SUBJECT: AMENDMENT 66 - LICENSE CONDITIONS 11, 21, 27, 41, 49.G., AND 50.B.2.

TECHNICAL EVALUATION REPORT

DOCKET NO. 40-6659 LICENSE NO. SUA-551

LICENSEE: Petrotomics Company

Figure 5.1-1

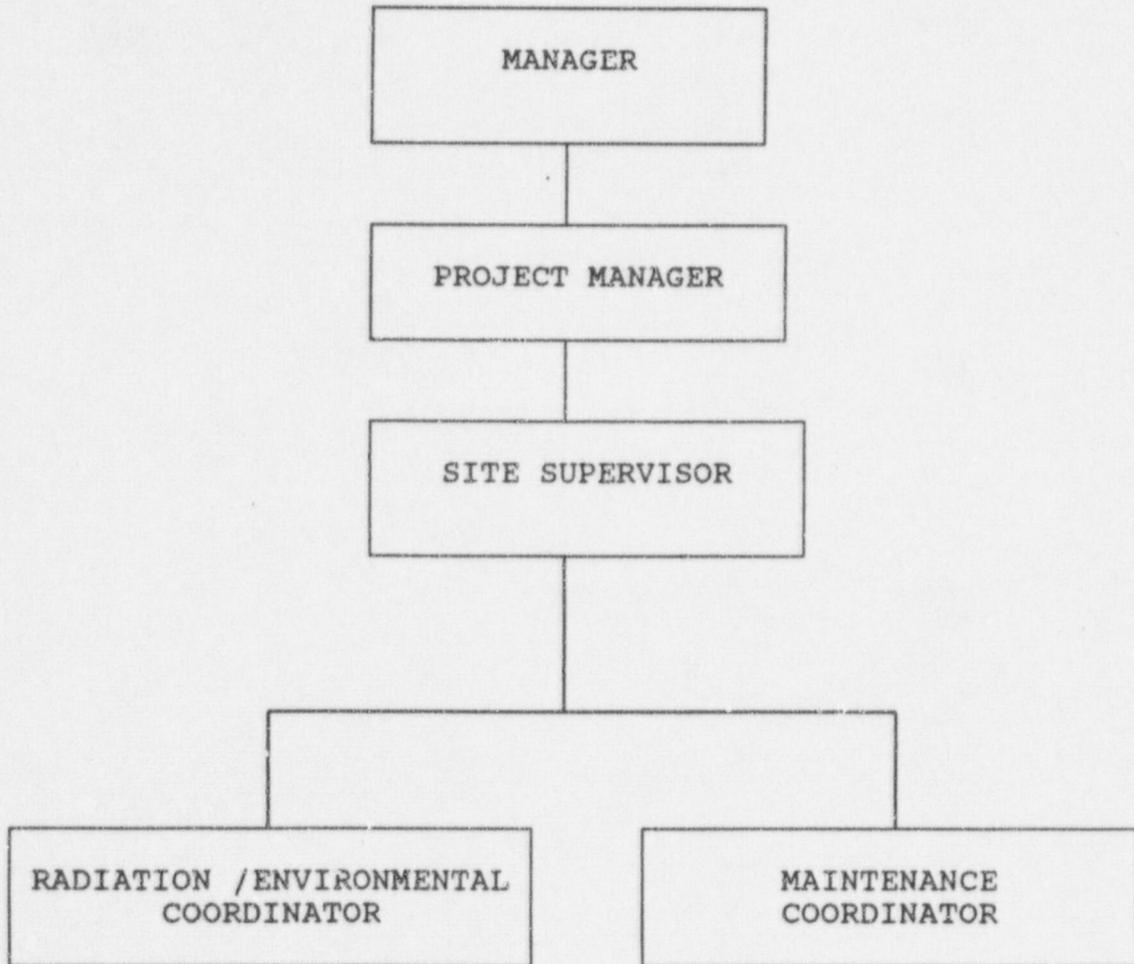
Figure 5.1-1

Figure 5.1-1. Change to reflect the current reporting organization chart.

Revise to reflect the current reporting organization chart.
